Metro Inner Development Assessment Panel Agenda

- 3.1 Lot 2 (No. 454) Murray Street, Perth - Proposed 7 level mixed-use development containing 68 tourist and visitor accommodation units and a ground floor café – DAP/26/03083

RESPONSIBLE AUTHORITY REPORT – FORM 1	
DAP Name:	Metro Inner DAP
DAP File No:	DAP/26/03083
LG Reference:	DAP-2026/5068
Proposed Development:	Proposed 7 level mixed-use development containing 68 tourist and visitor accommodation units and a ground floor cafe
Value of Development:	\$10 million
Owner:	Rich Peace Pty Ltd
Applicant:	Urbanista Town Planning
Local Government Area:	City of Perth
Responsible Authority:	City of Perth
Authorising Officer:	Julia Kingsbury, General Manager Planning and Sustainability
Application Acceptance Date:	25 March 2026

RESPONSE TO REQUEST FOR FURTHER INFORMATION

1 ROOF & SHADOW PLAN 21June
dA1.06 1 : 100

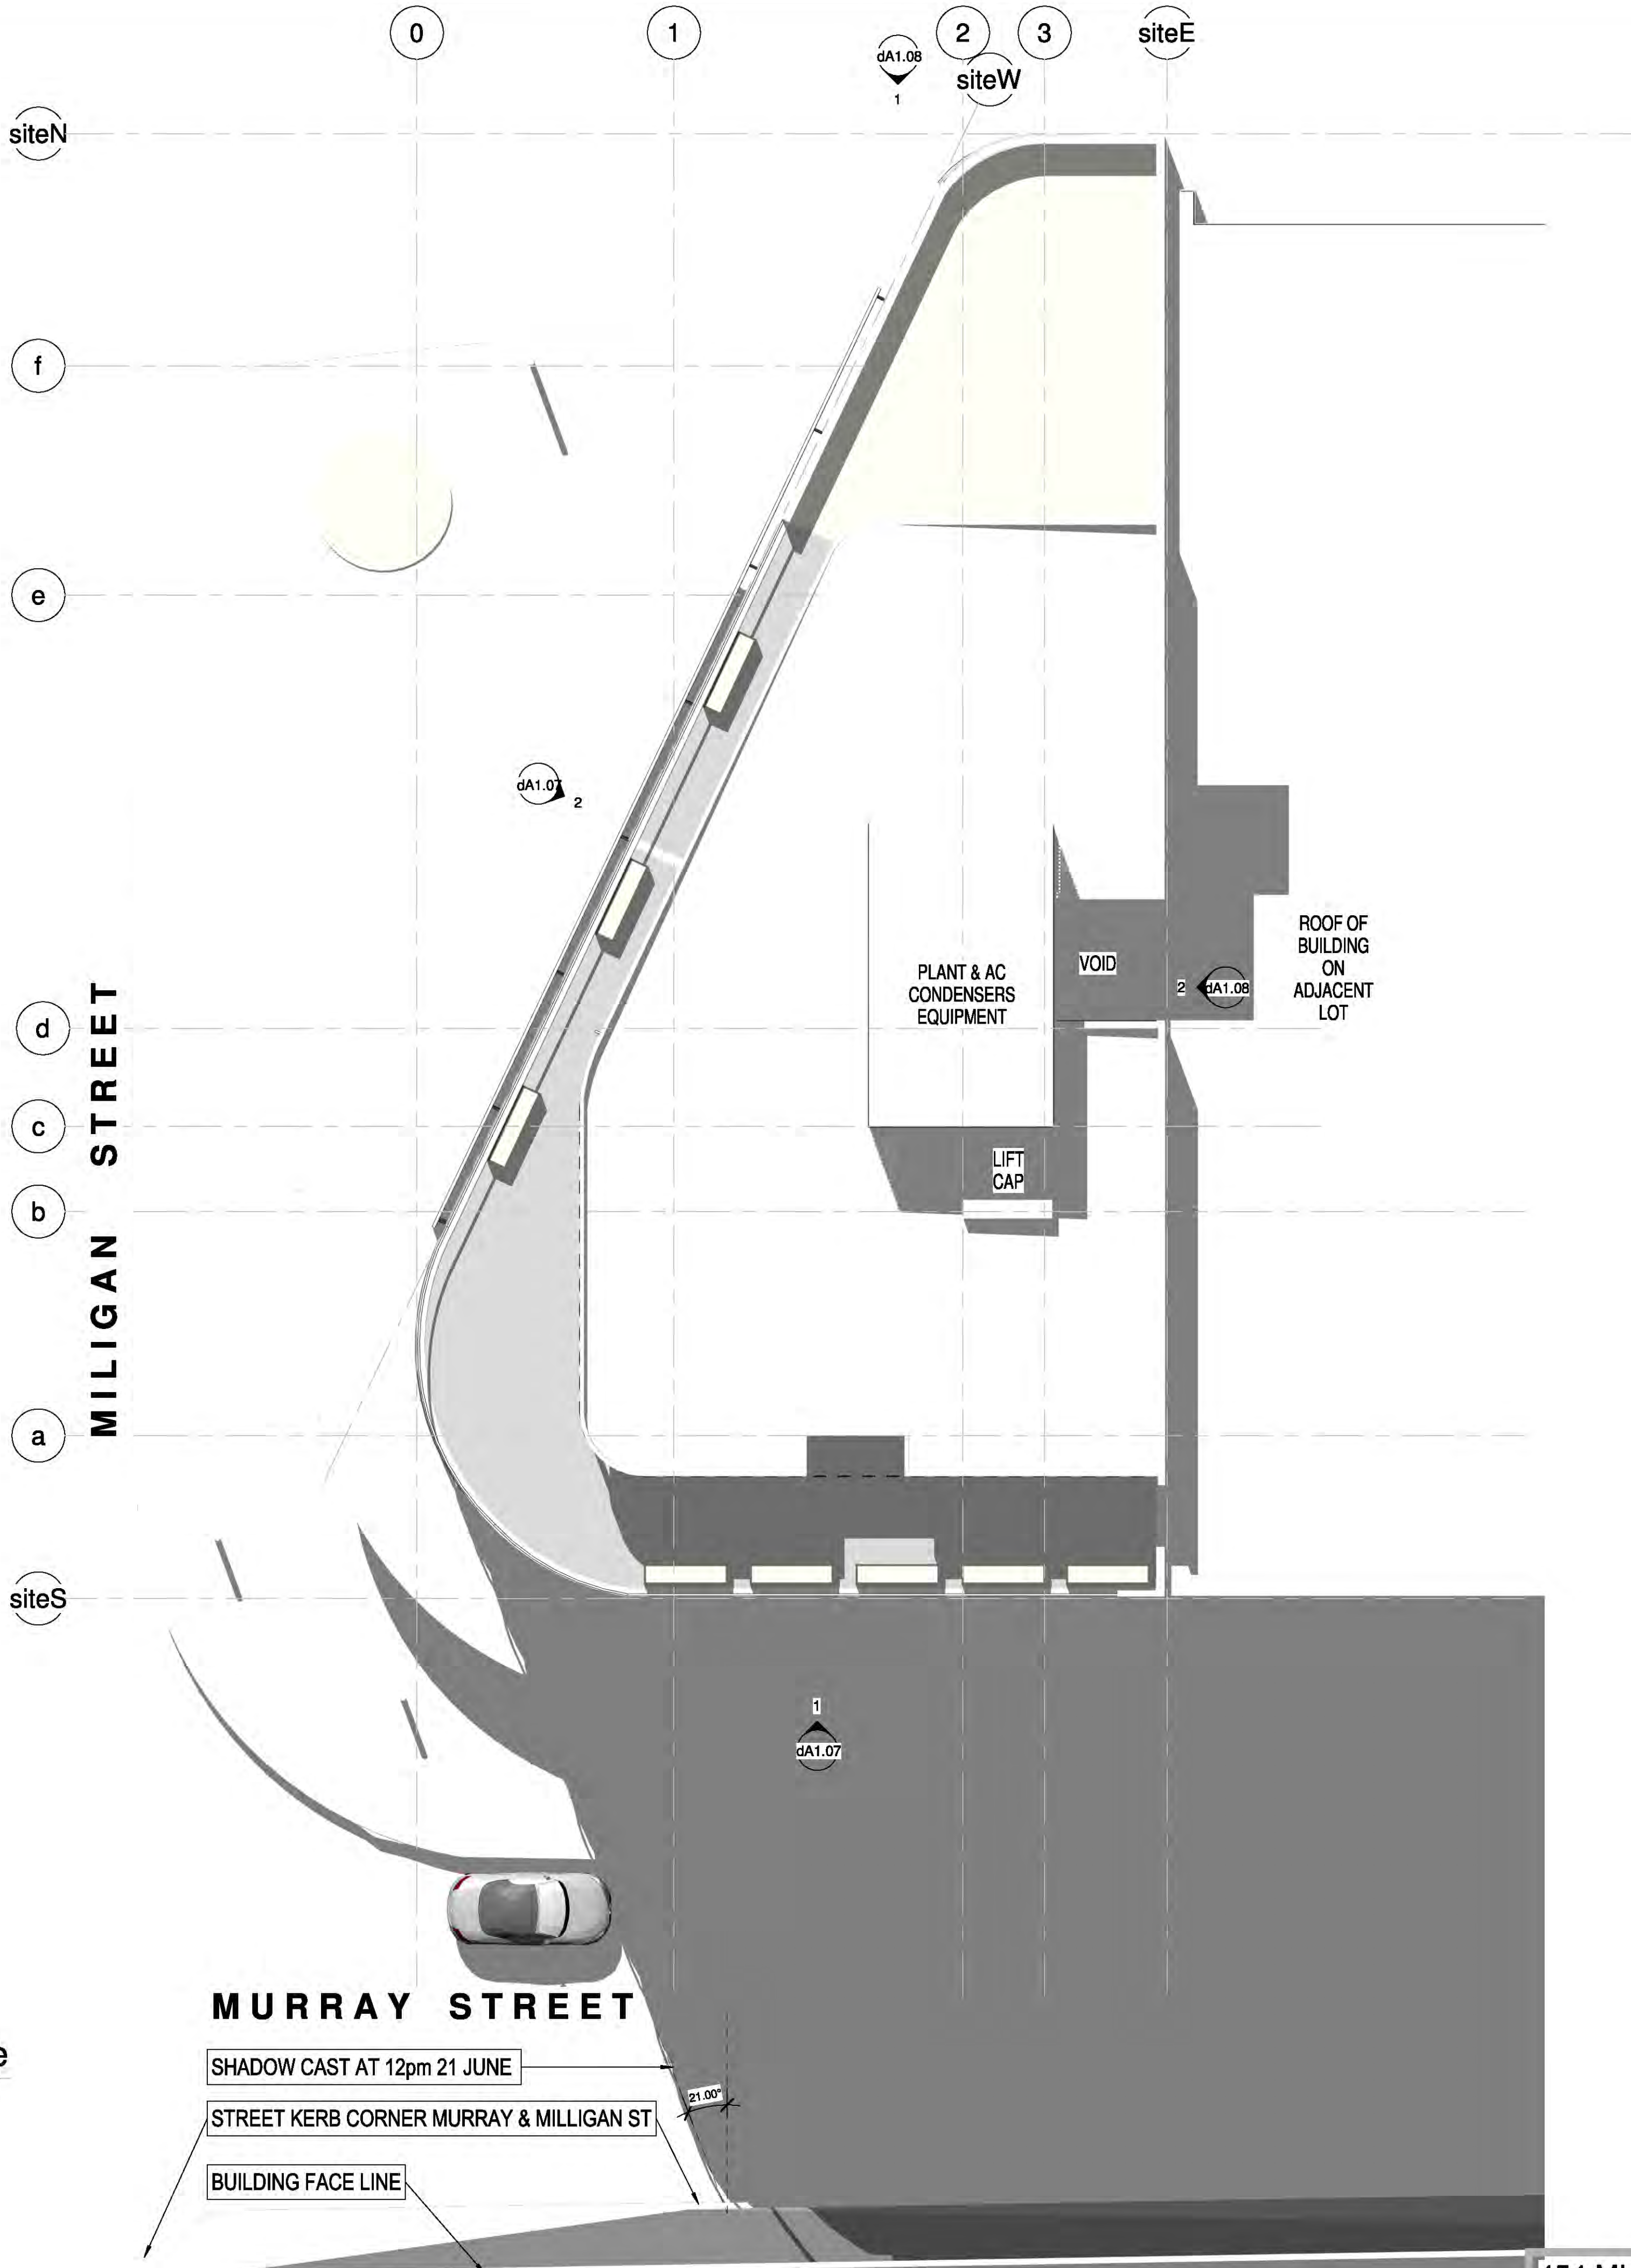
The development further proposes a variation to the maximum building height, whereby the upper levels of the development should be setback within a 45-degree height plane measured from the street to the south (Murray Street). It is noted that whilst the development varies the setback requirements to the upper levels, the proposal is consistent in height and configuration with the existing building directly adjoining the subject site at 448 Murray Street. which also projects into the 45-degree height plane, and will create a cohesion between the two building facades. It is further considered that within the immediate surrounding area, development has largely been defined by buildings that are lower in height, with minimal building articulation and no consistent building form. The proposed building form is therefore not considered to have an impact on the streetscape and the variation can be supported.
